HEMTT A4 and  
PLS A1 Trucks...

## STEERING COLUMN WIRING HARNESS CHANGED!

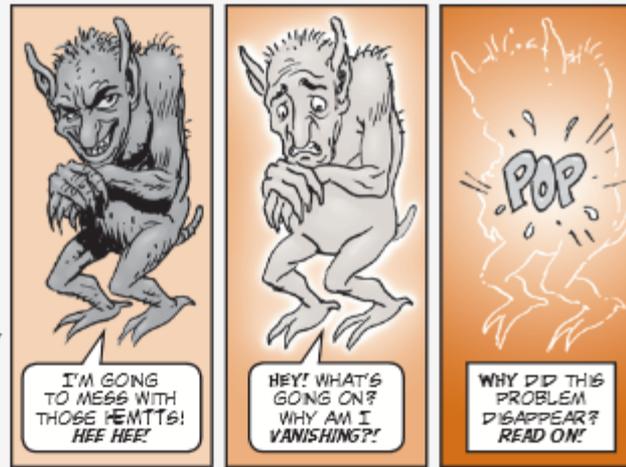
A production issue caused a cab wiring harness to rub against a grease fitting on the steering column of these HEMTT A4 and PLS A1 trucks. That contact can lead to a damaged wiring harness, including sparking of exposed wires or shearing of the wires. But the good news is, steering and other safety-related functions aren't affected.

More good news is that Oshkosh Corporation will inspect and modify suspect trucks. In fact, Oshkosh will provide the required parts and labor to correct this problem at no cost to units. The repair work will include removing and disposing of the problem grease fitting, installing a plug to fill the opening, and adding two half-inch wide cable ties.

What about the TMs? The HEMTT A4's TM 9-2320-326-14&P (EM 0288, May 09), and the PLS A1's TM 9-2320-319-13&P (EM 0298, May 09) will be updated in the next revision. The grease fitting will be removed and two half-inch wide cable ties will be added.
